DES A Specialty Products™			
Title 6-Button Remote			
Size C	Number 6005Zilog	Rev A	
Date	Thu May 13, 2004	Drawn by	Barry Atkins
Filename	6005-6ButtonRevA.sch	Sheet	1 of 1

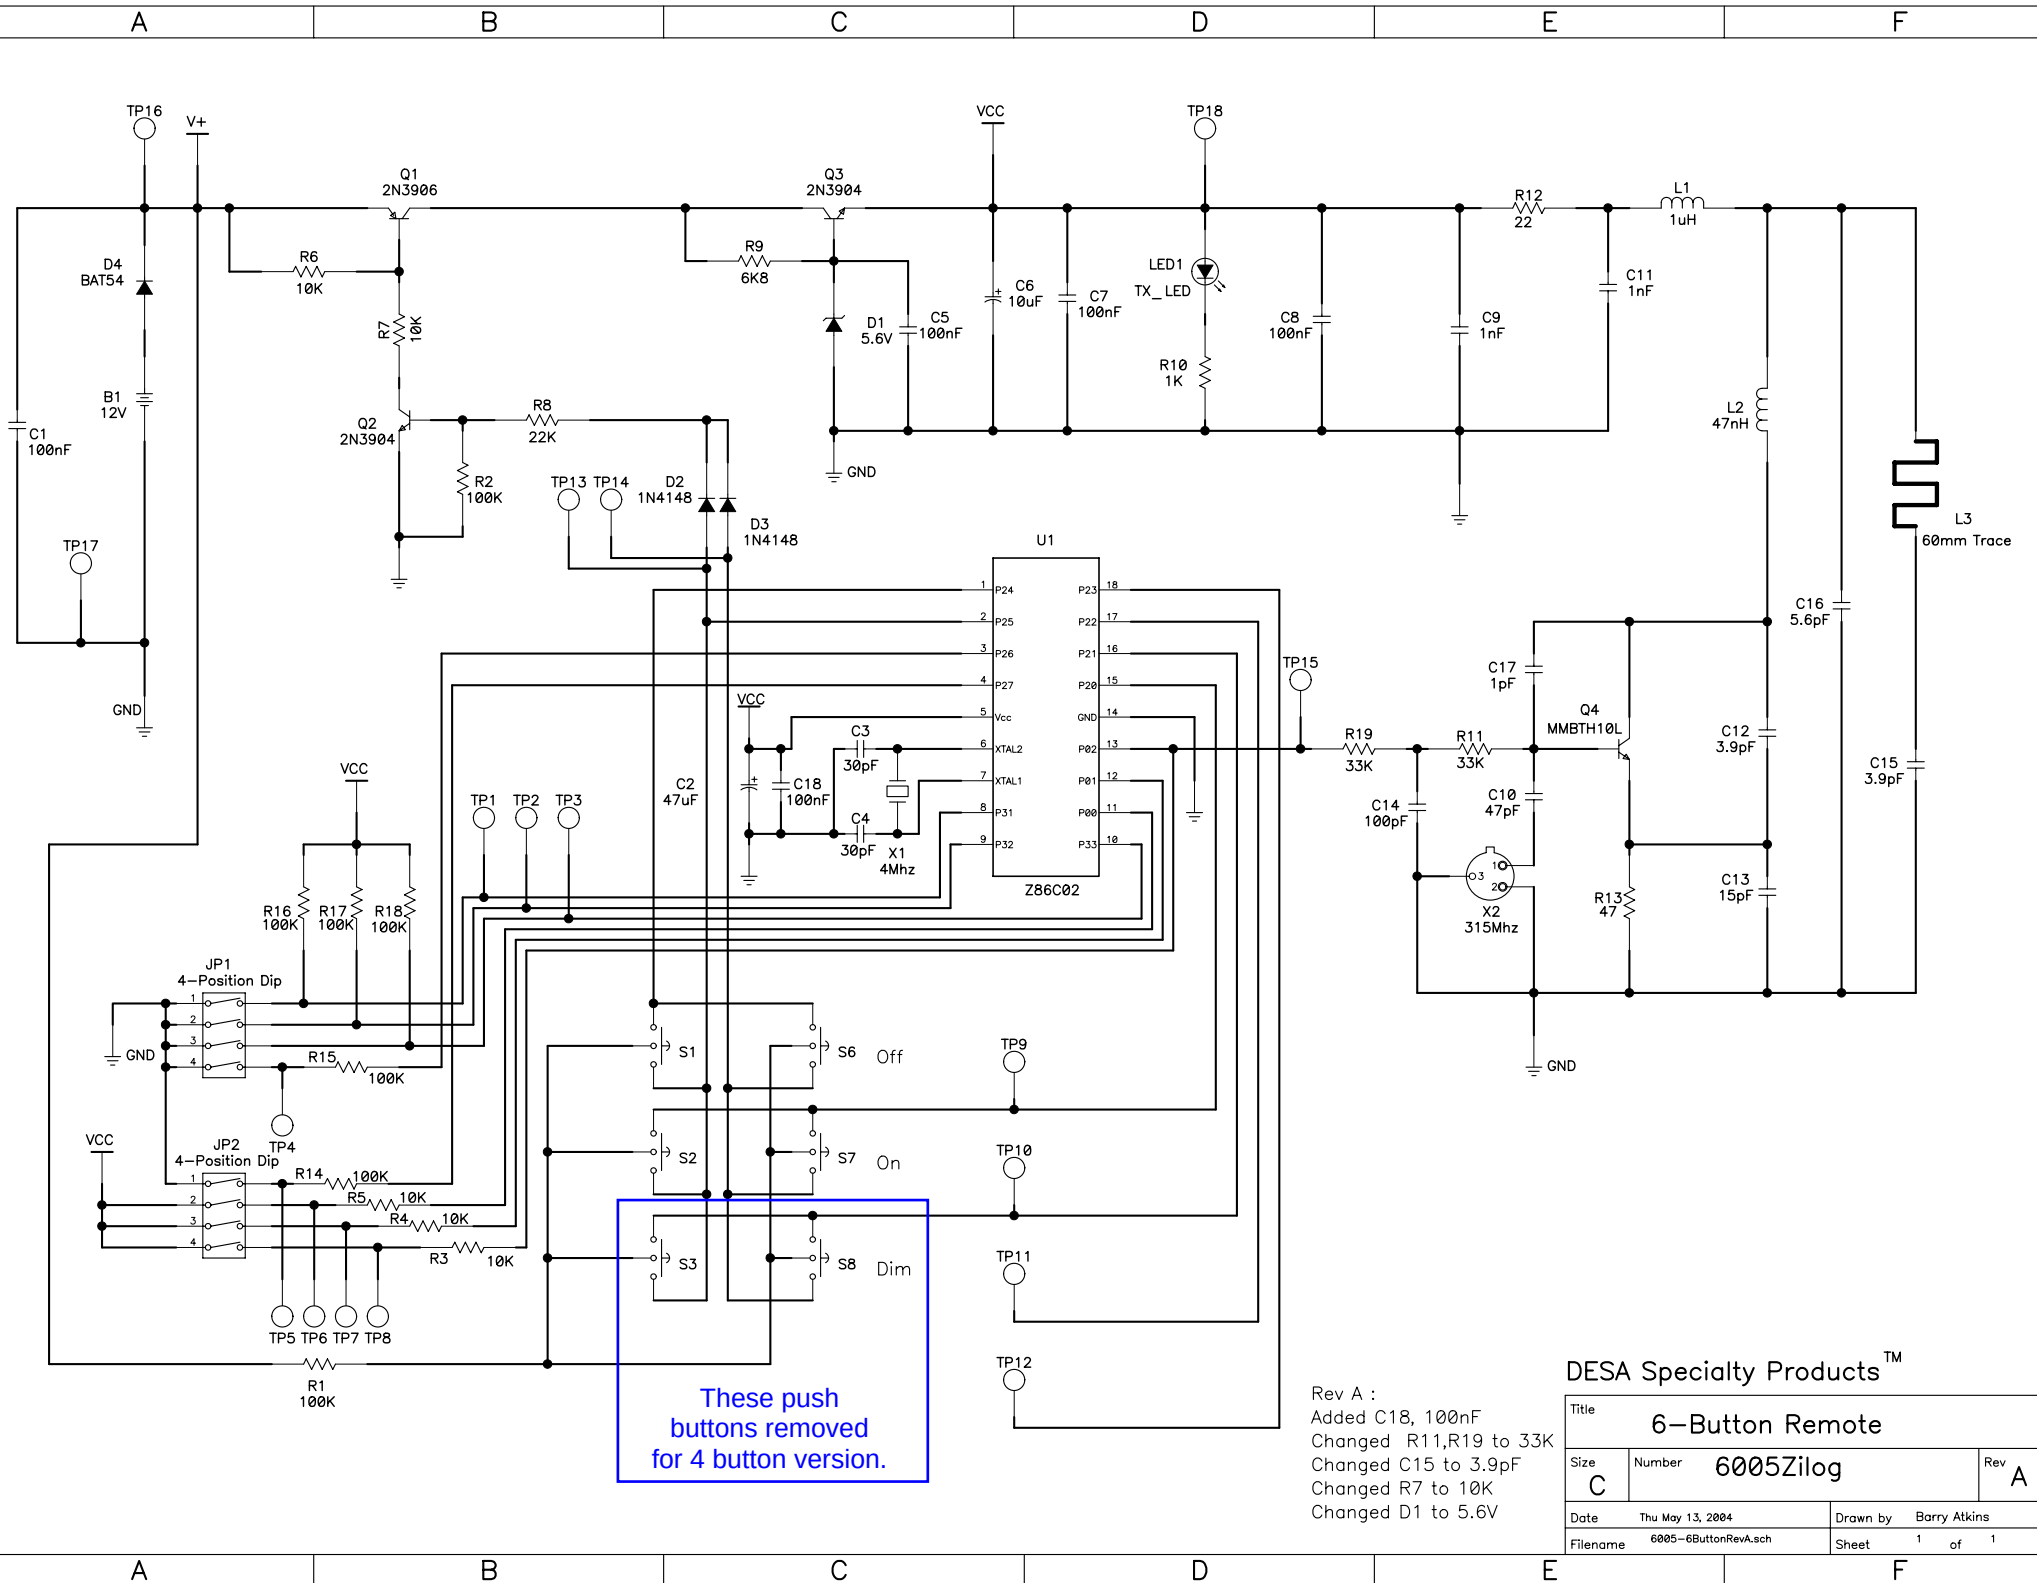
Rev A :
 Added C18, 100nF
 Changed R11,R19 to 33K
 Changed C15 to 3.9pF
 Changed R7 to 10K
 Changed D1 to 5.6V
